ADDENDUM 1

2020-01

Supplemental Landscape Services for Bluewater Bay Municipal Services Unit (MSBU)

Bluewater Bay MSBU Maintenance Boundary Map

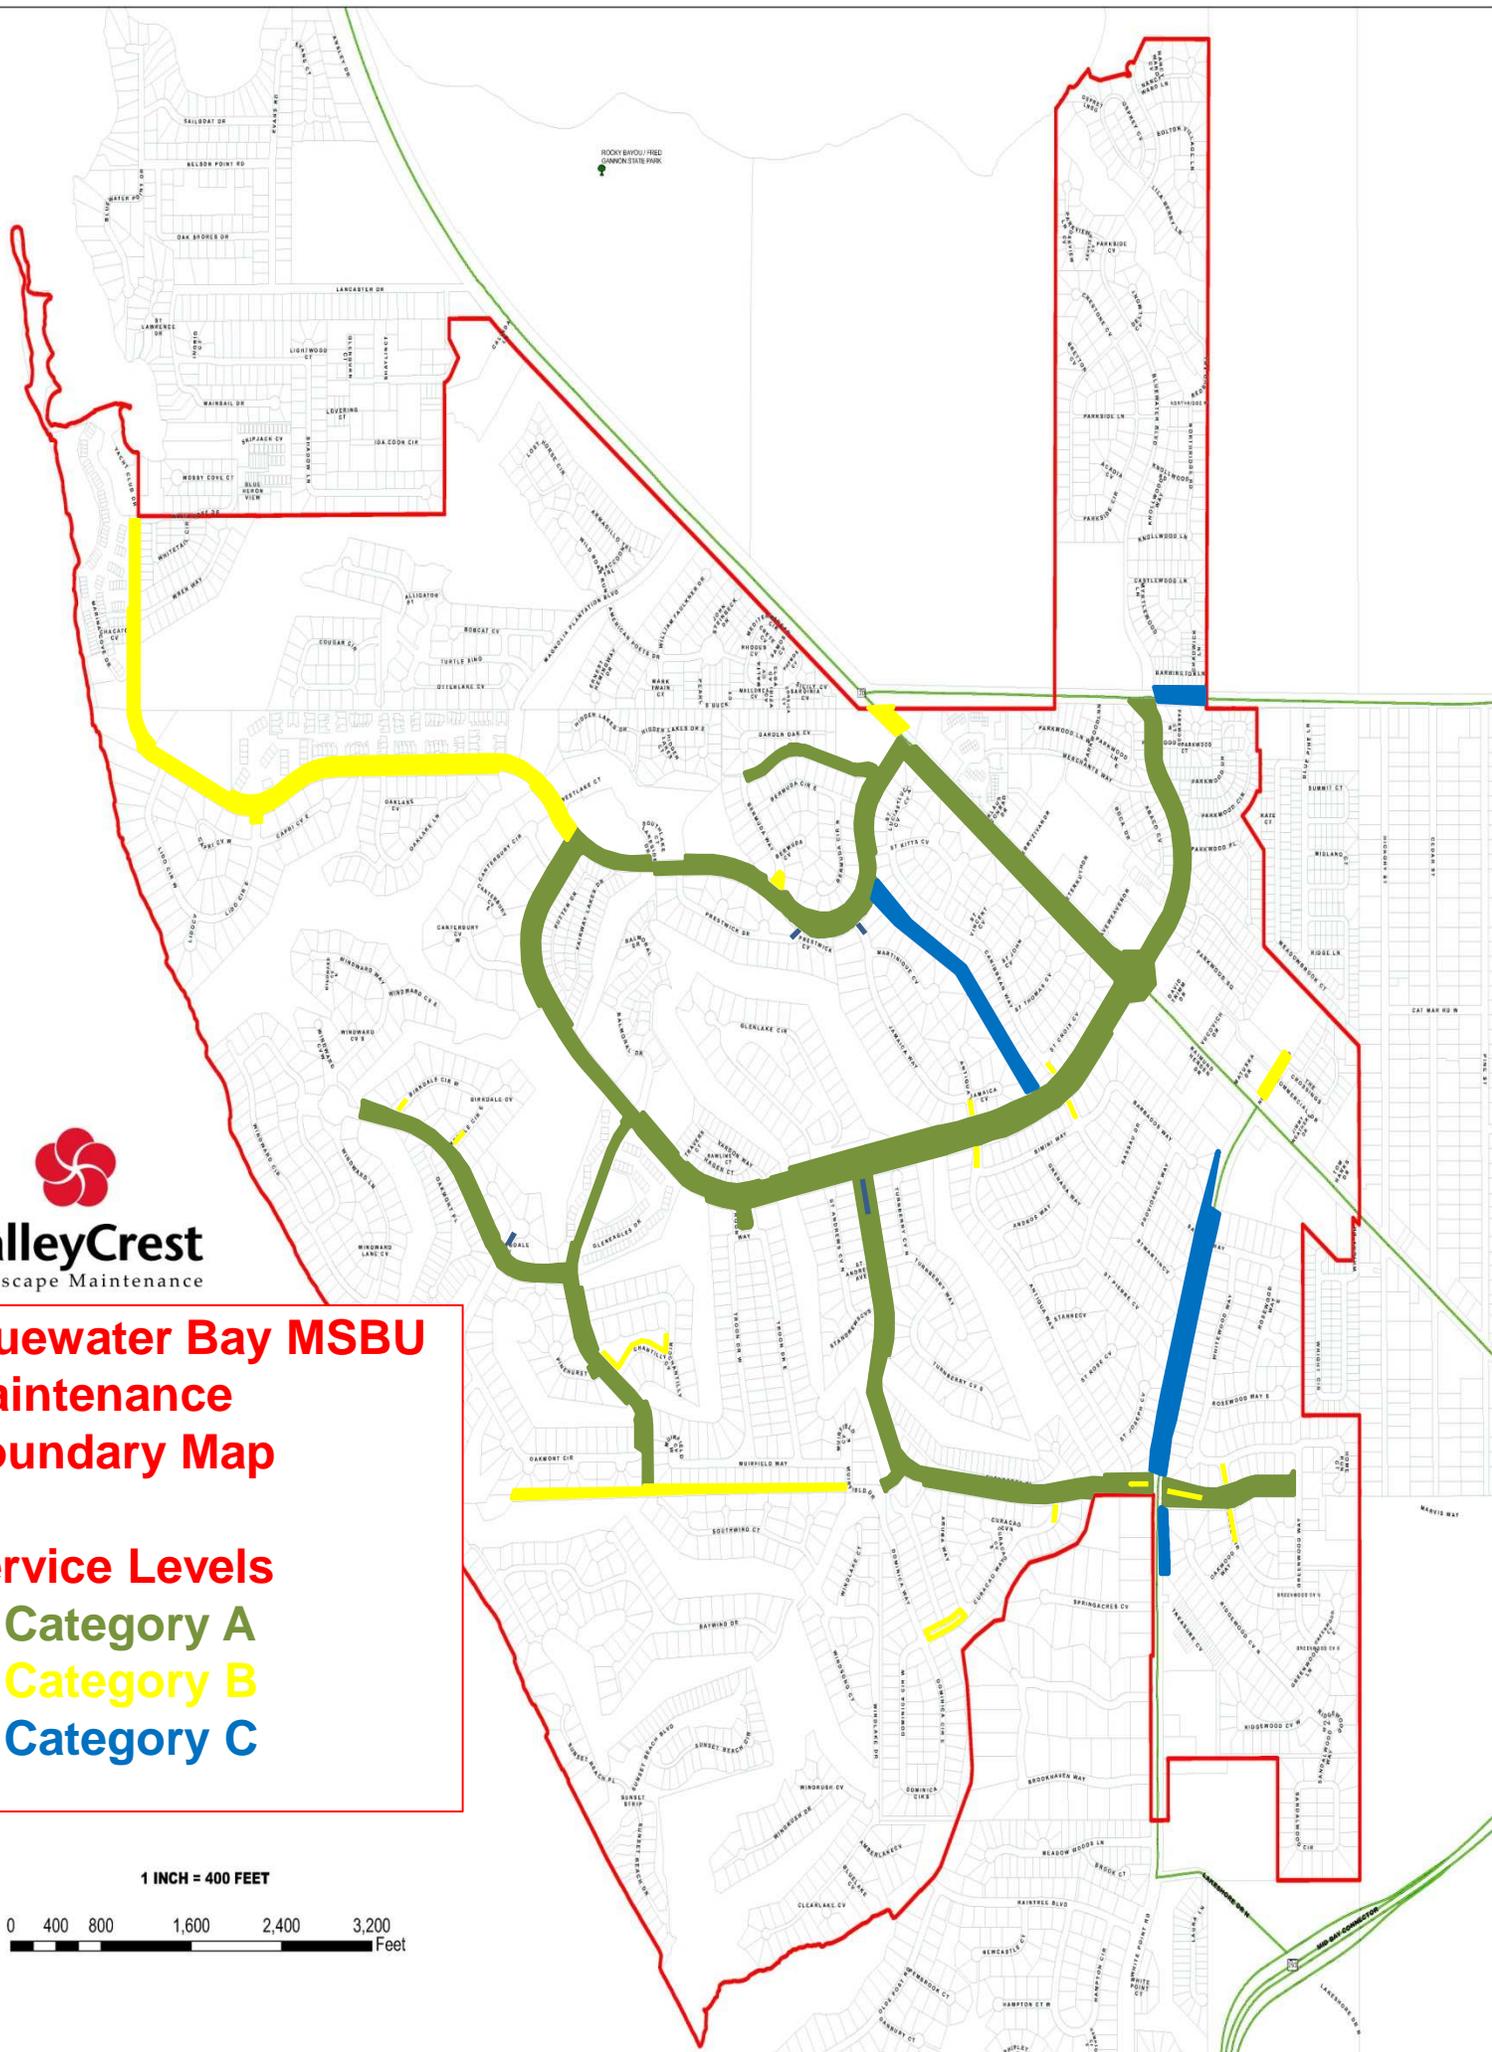
5. As detailed on the SUMMARY BID FORM starting on page 46 of 56, I understand that there will be a Service Level A, B and C. However, no site maps have been provided with the bid specifications to show what all areas are included in this bid and specifically which areas are to be maintained at Level A, B and C. Can you provide site maps of all areas to be included in this bid and also indicate which areas are to receive either Service Level A, B or C? **Please see attached.**

Service Levels

- **Category A**
- **Category B**
- **Category C**

Bluewater Bay MSBU Irrigation Map

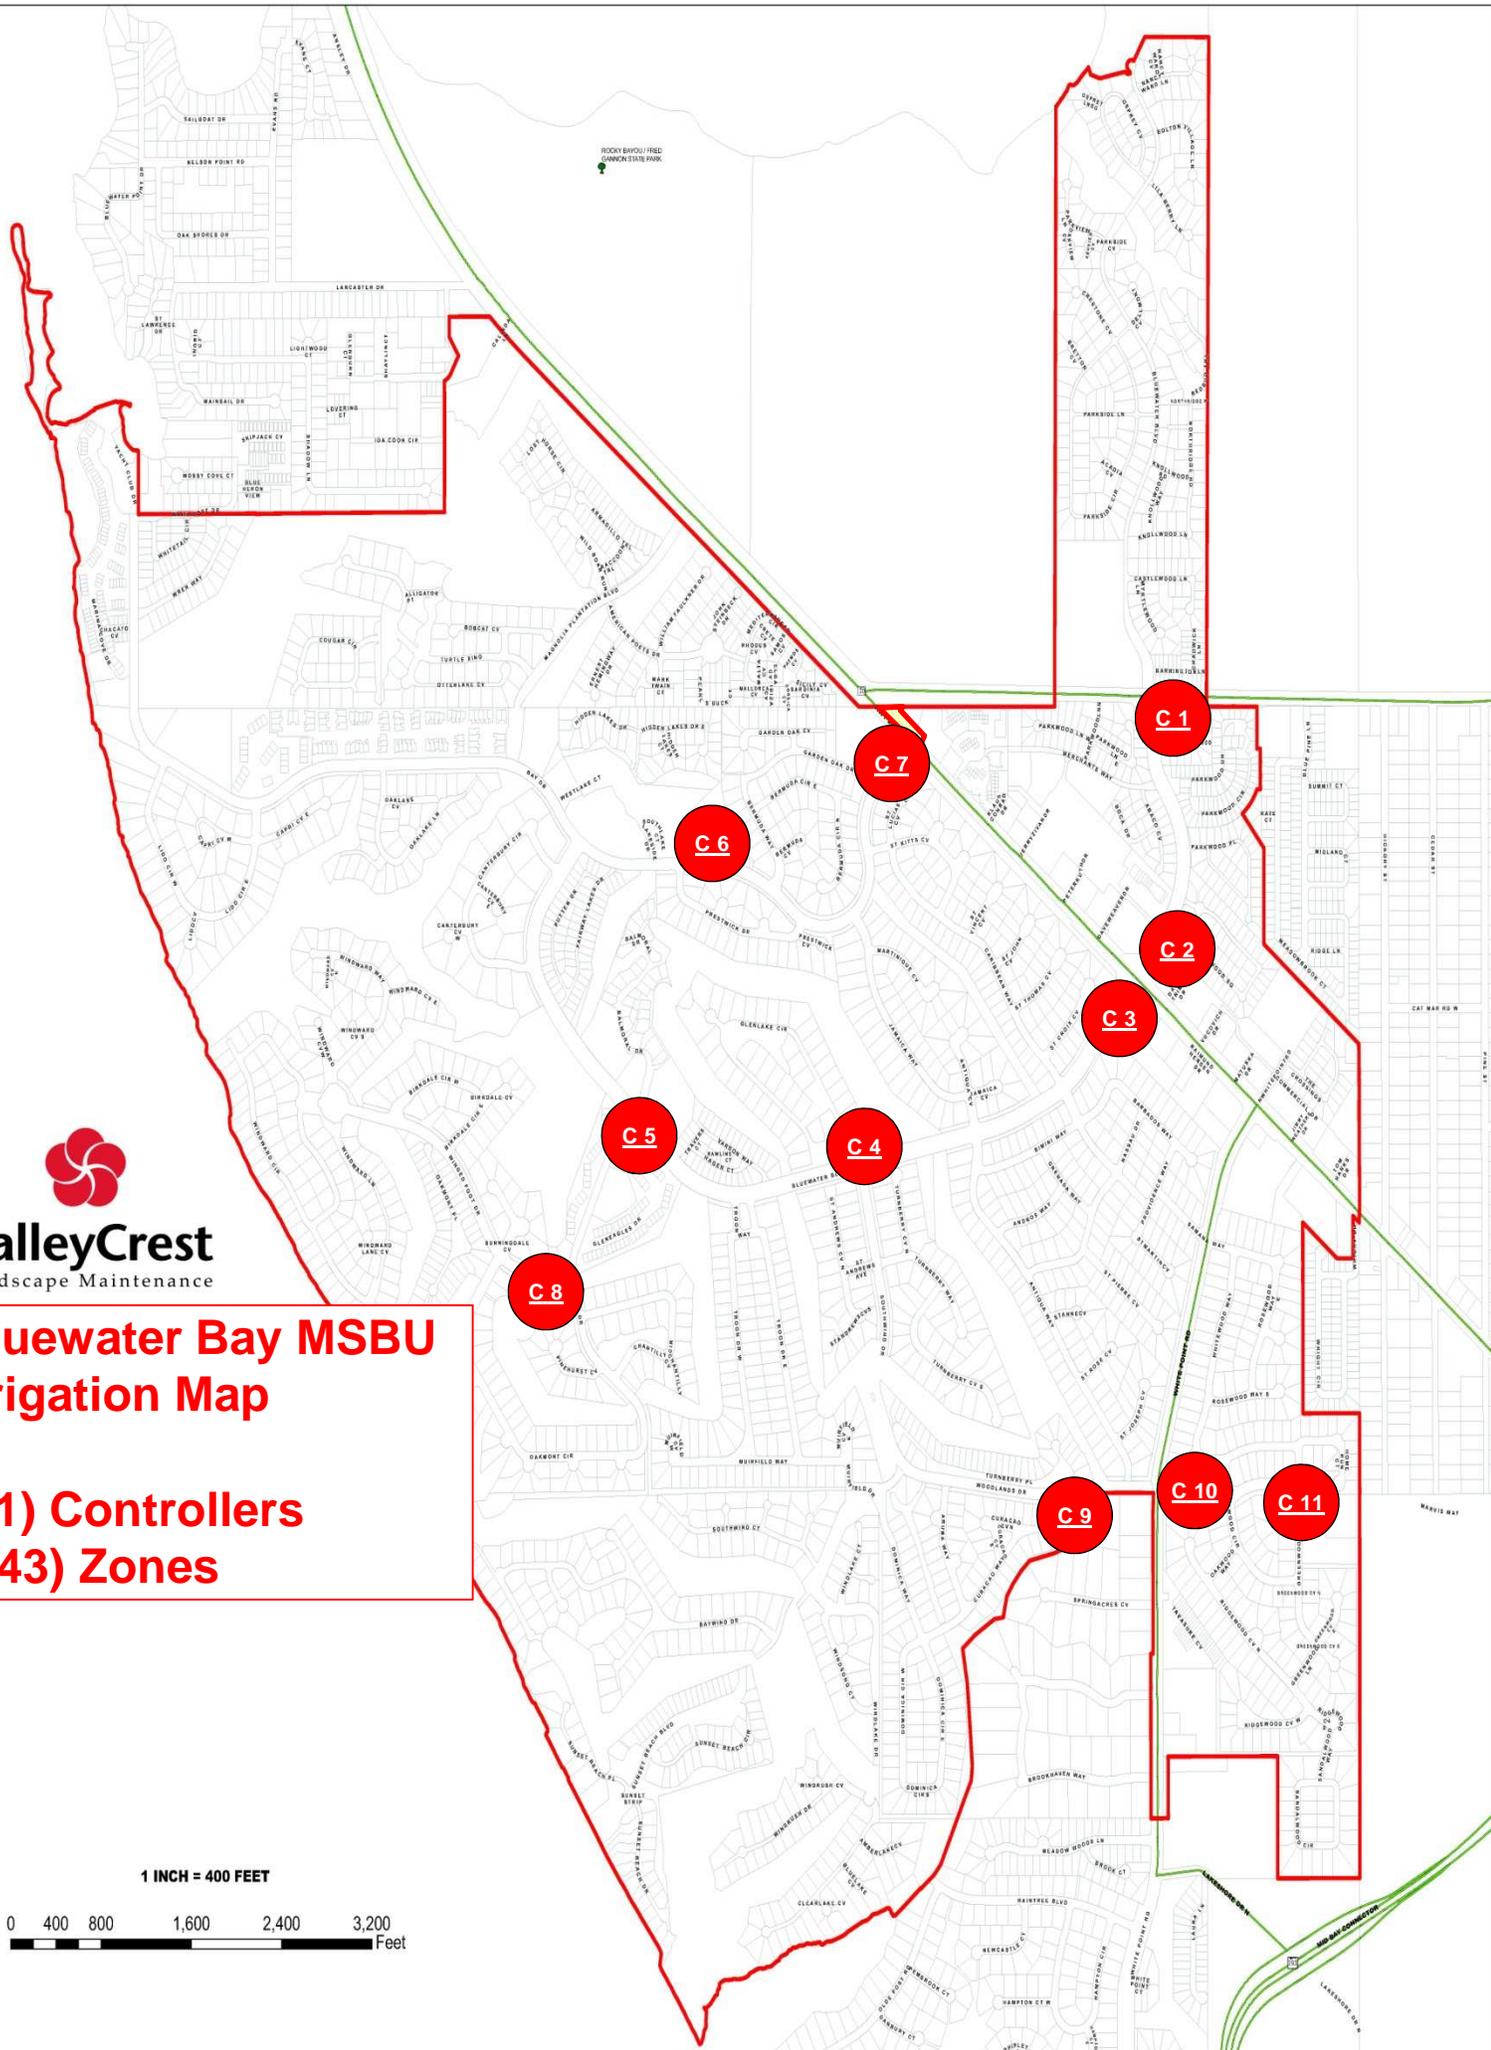
4. Section IX. IRRIGATION SYSTEM, page 44 of 56 – Can you please provide the total number of irrigation controllers and the total number of irrigation zones that will need to be maintained per this bid? **Please see attached .**

(11) Controllers
(143) Zones
